Req 235: a dormitory level per year in every house

The Architect, 13 October 2026, for Godric (your voice note, 8.45 am). Plans north up at 1:200, sections at 1:500 on one datum (heights above the castle's datum; the seventh floor +36.4). Red dashed: as built now. Nothing here is built yet.

The common room's level, +36.4

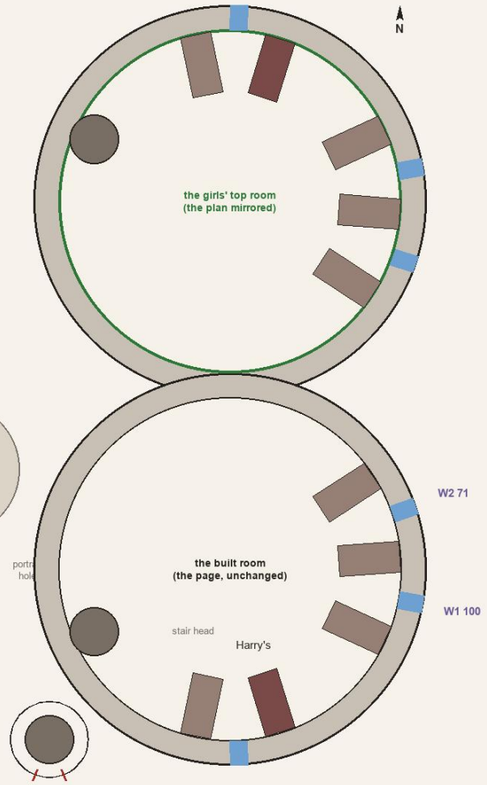
Green ring: the girls' drum (proposed), 12 m north, behind the tower from the lake, sharing a stretch of wall; it rises from the south range. 1:200.

Inset, lower left: on the six levels below the top, each stair walled in, a door (red) into each room (PoA 13).

Under 235.1 this room is the same, 20.4 m higher: W1 and W2 look over every roof; W3 over the south range to the crag's edge and the lake below. Under both, the Common room places the girls' door (any free stretch from the little door round by the west to the bookcase), and the girls' drum goes into the faces and sections.

235.1 The built room on top

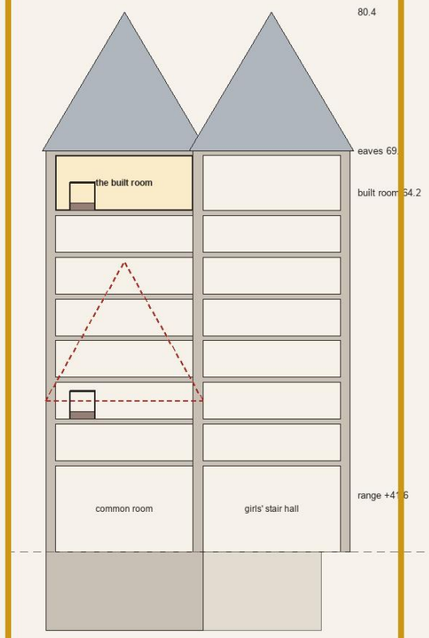
235.1 (recommended). Seven rooms a stair, a room per year group kept all seven years (CoS 5's sign). The built room goes to the top of the boys' stair, its plan and page unchanged; its floor rises from +43.8 to +64.2 (7.4 to 27.8 m above the common room). The open stair head on the page is right for a top room. Below it, six rooms at 3.4 m storeys (3.0 clear). Moves: the model (version 7), the Dormitory page's one number, its windows' heights; req 225's line (W2's sill +65.3, the beech 22 degrees down). 225's choice holds either way.

235.2 The built room at the foot

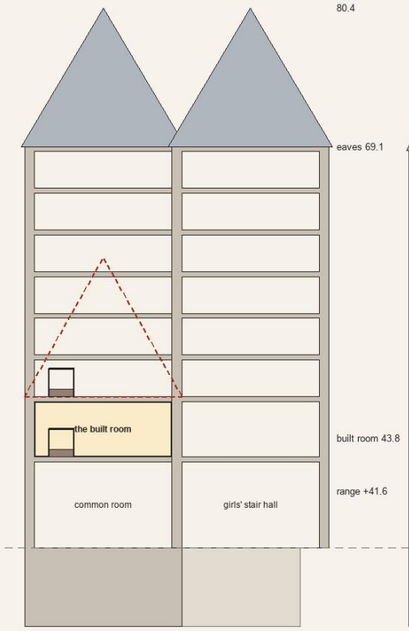
235.2. The built room keeps +43.8, the lowest of the seven; six rooms above it. Departs from the books: Harry's room is not at the top (CoS 5, GoF 12). The stair must run on up out of the built room, so its page still changes (the stair head becomes a stair going on up). Same heights as 235.1.

Ravenclaw (both options)

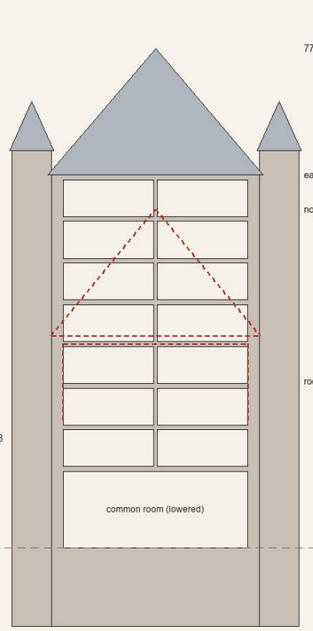
Both options: Ravenclaw's common room lowered to +36.4 (my number; proposed), its wider drum split, a boys' and a girls' room a level, each on its own stair from a lobby behind DH 29's one door. Astronomy raised a stage to stay the highest (HBP 27); its classroom with it.

Hufflepuff and Slytherin, below ground (both options): two passages off the common room's level, seven doors each (proposed)

Slytherin's room stays under the lake (low, CoS 12); Hufflepuff's off the stair down to the kitchens. A level per year down would sink 25 m into the rock; your "levels/space" is met on one level. Heights: the boys' and girls' drums 69.1 to the eaves, cones to 80.4; Ravenclaw 66.8 and 77.1; the Astronomy ramparts 83.2, its stair turret 87.0. DH 31's three highest stay the three.
